**MOORE PUBLIC SCHOOLS -
KELLEY ELEMENTARY SCHOOL
NEW ADDITION / STORM SHELTER**
Moore Public Schools - Moore, Oklahoma
AGP - Moore, Oklahoma

ADDENDUM NO. 2
November 17, 2022

FRENCH DRAIN DETAIL

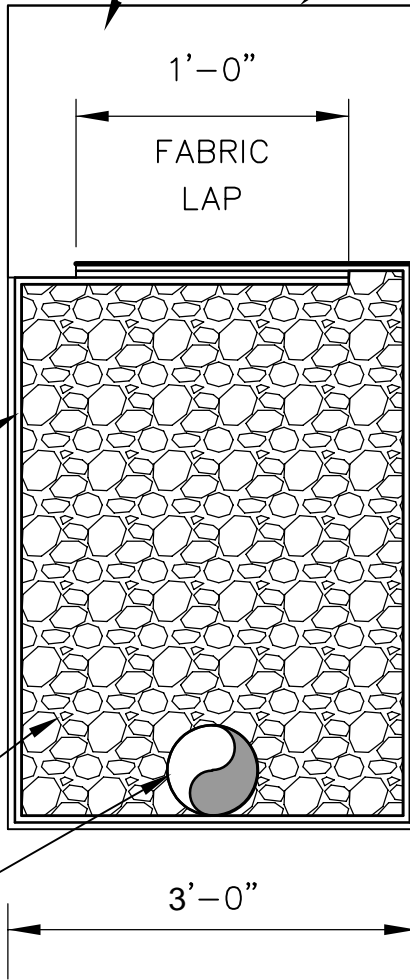
According to current City of Moore Stormwater Management Criteria, section 8.1.1 the city allows the use of Low Impact Development used in any zoning district. For the 2760 S.F. referenced Kelly Elementary storm shelter addition, Moore Public Schools would propose to use 137 linear feet of 3-foot-wide by 3-foot-deep infiltration trench per the attached detail.

The proposed 3-foot-wide by 3-foot-deep infiltration trench consists of a 6" perforated PVC pipe that catches all roof water from the storm shelter addition, rock backfill with a porosity of 0.32 (AASHTO #57 stone), and a filter fabric with 1' of overlap. Considering the void area of 1.92 square feet, the infiltration trench is required to provide a total length of 137 feet in order to mitigate the additional stormwater caused by the storm shelter addition.

UTILITY SITE PLAN

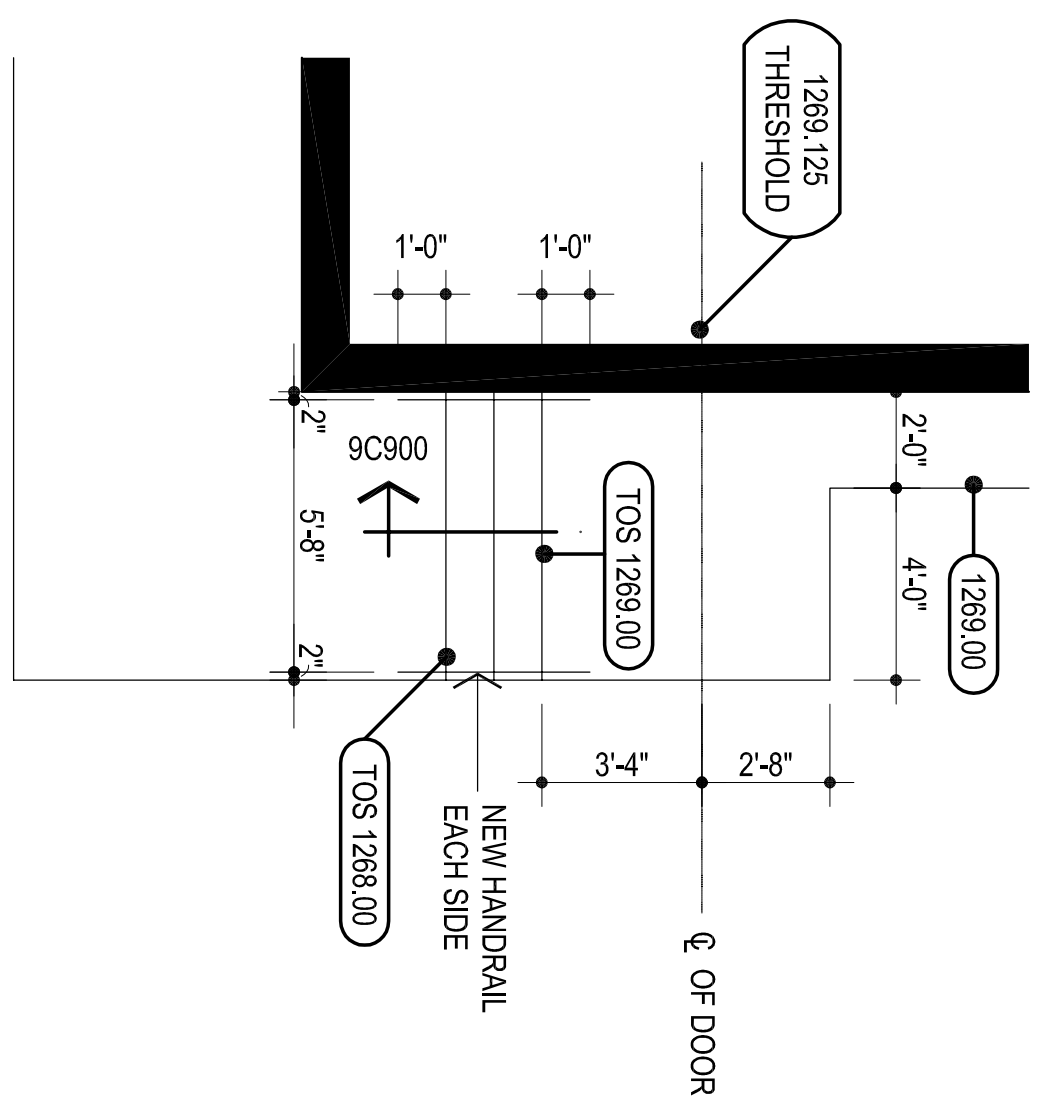
1. Refer to attached Drainage Report Review Response Letter from the City of Moore.
2. Sheet C501, Detail 1, Utility Site Plan: added note "10" and revised note "10" in General Notes as indicated on attached replacement sheet.
3. Sheet C900, Detail 8, French Drain Detail: revised trench width as indicated on attached replacement sheet.

4 DOOR SCHEDULE

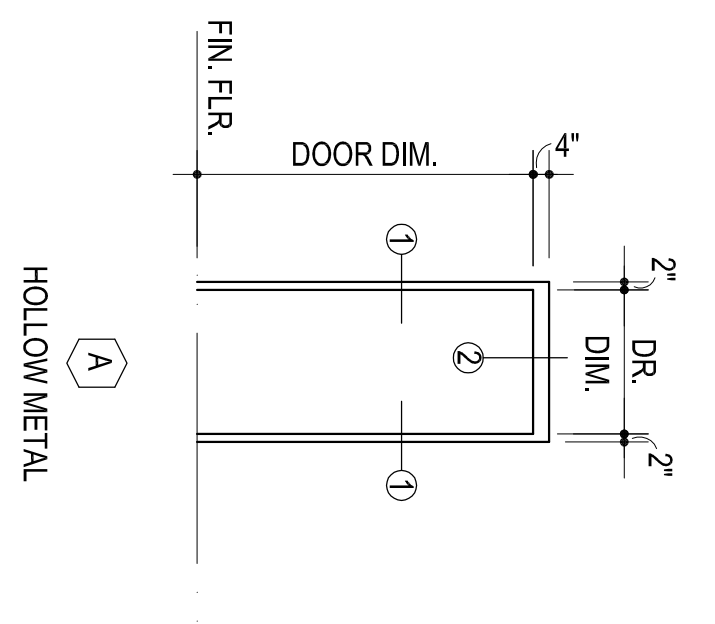
2. Sheet A601, Detail 4, Door Schedule: revised door materials in schedule. There are NO wood doors on this project. Refer to replacement sheet.

sheet no:
E401

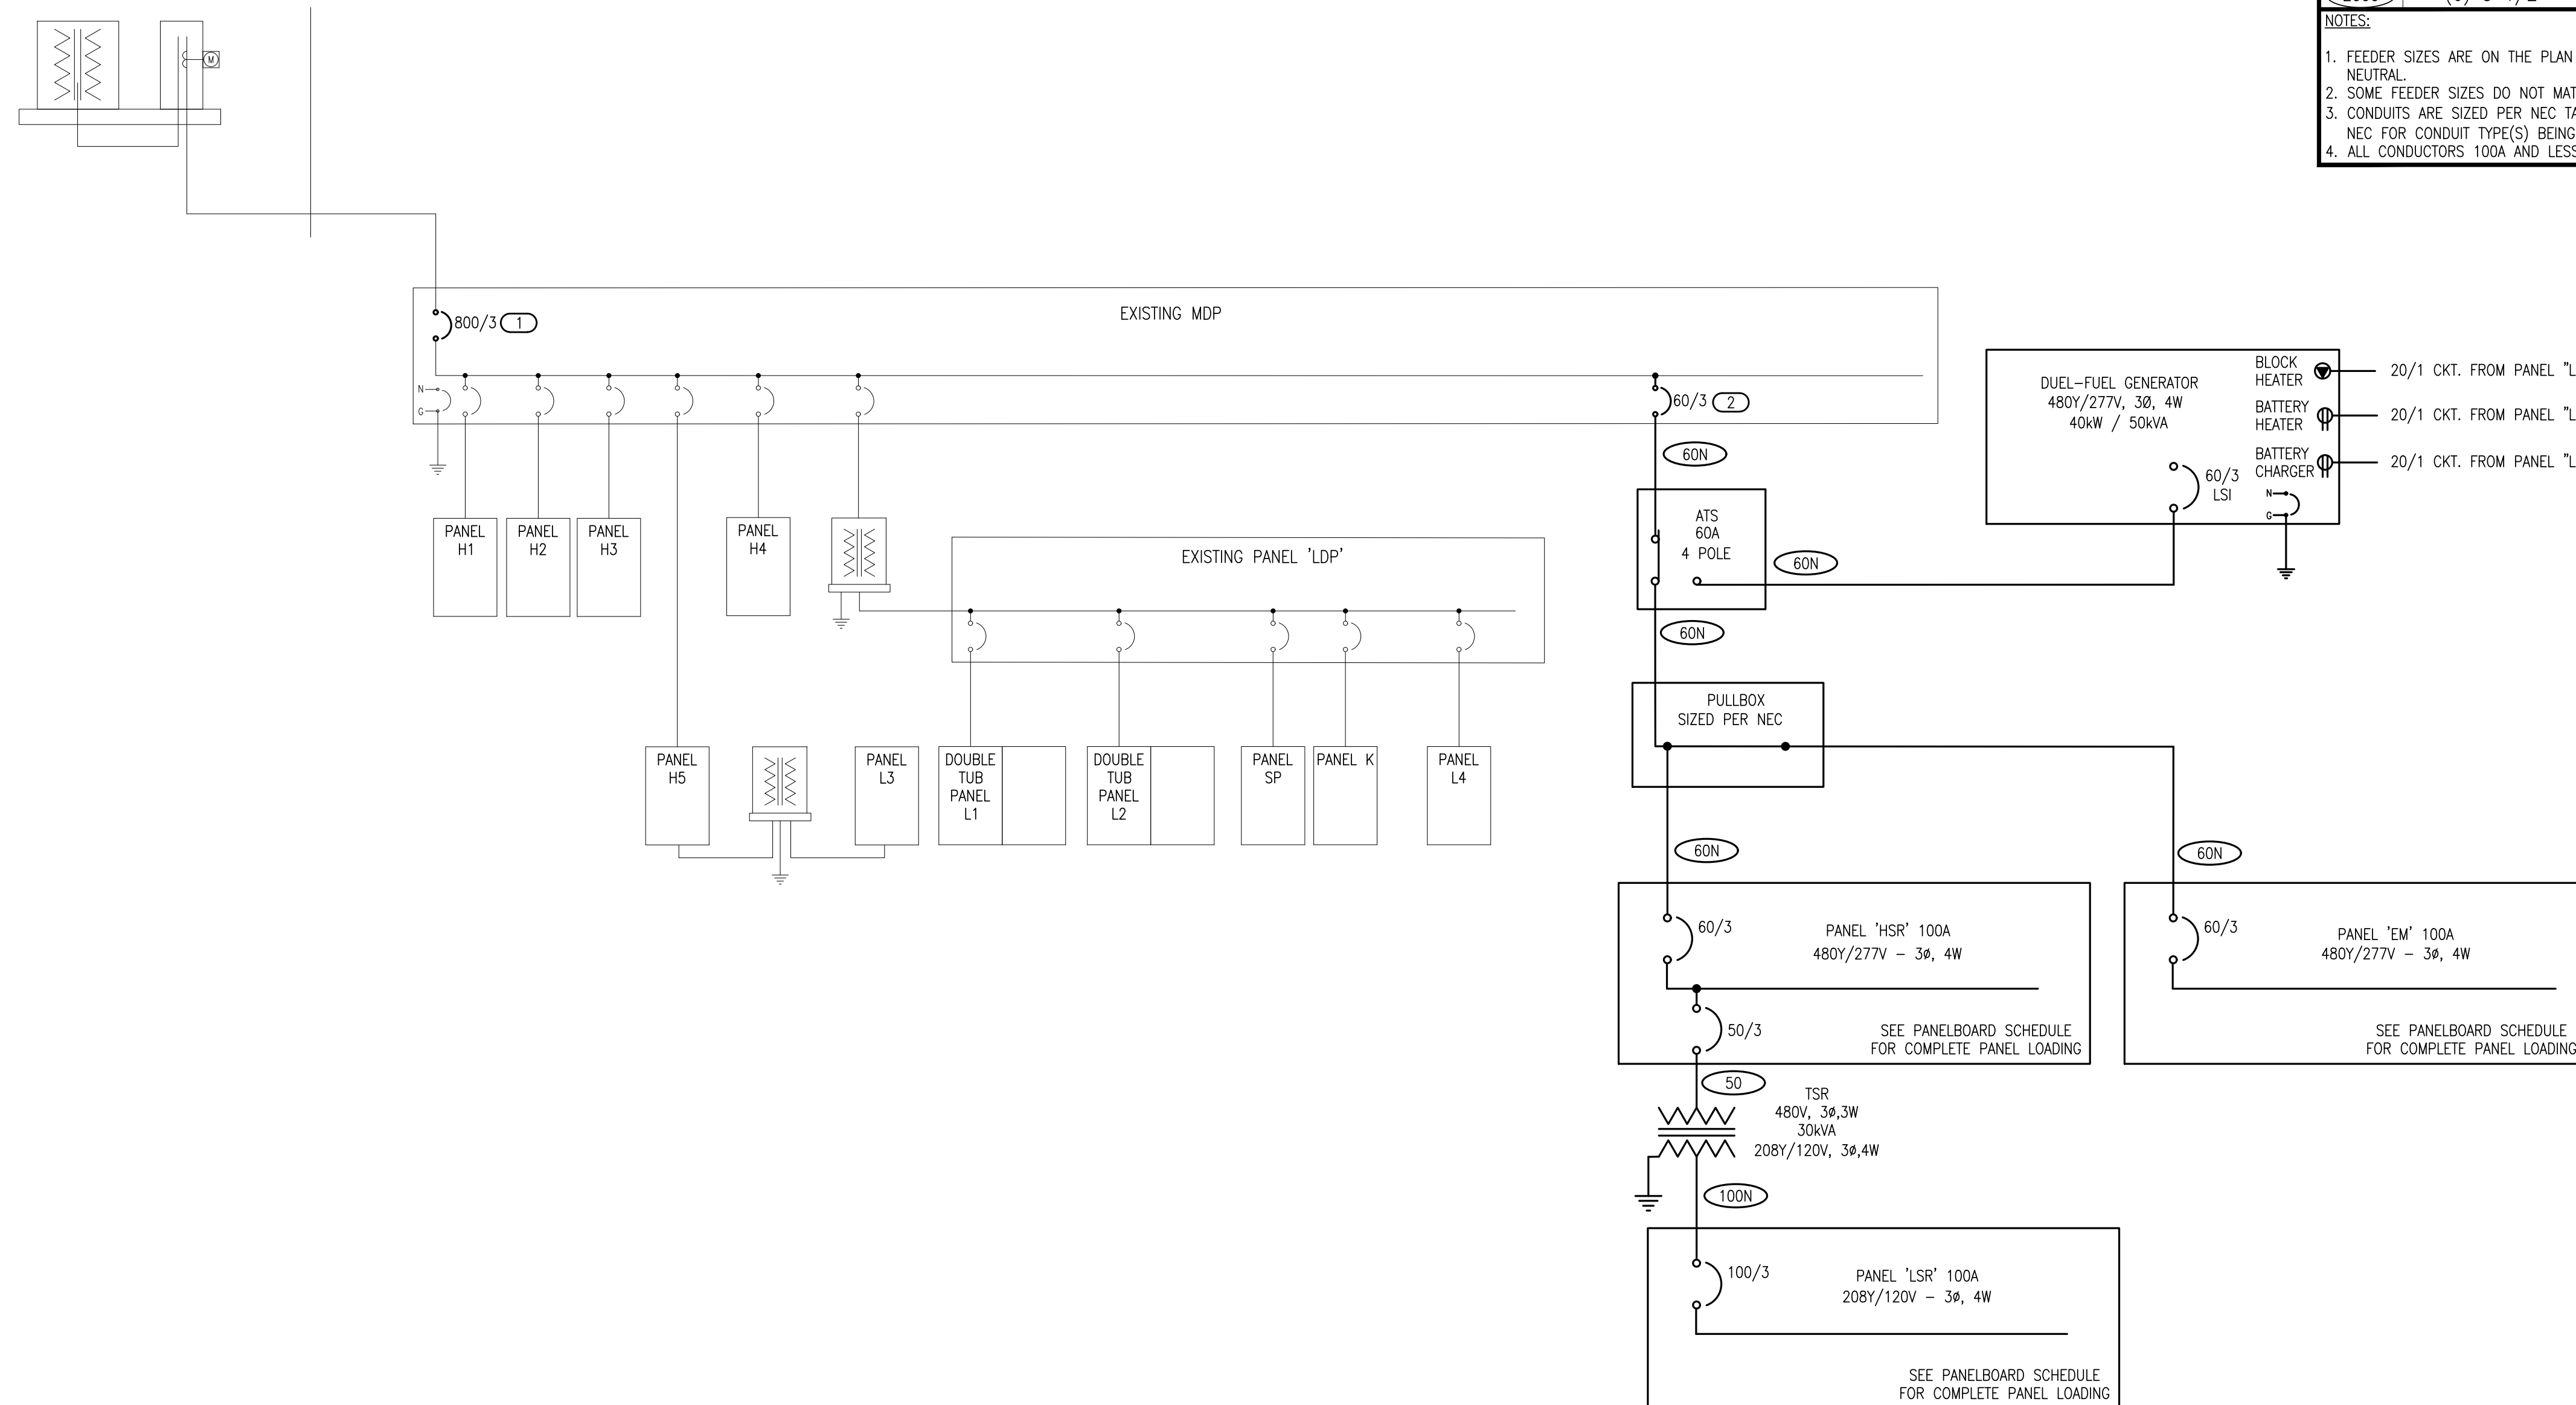
- **SHEET E401 – ELECTRICAL ONE-LINE DIAGRAMS**
 - Refer to drawings for changes shown in clouds and deltas.
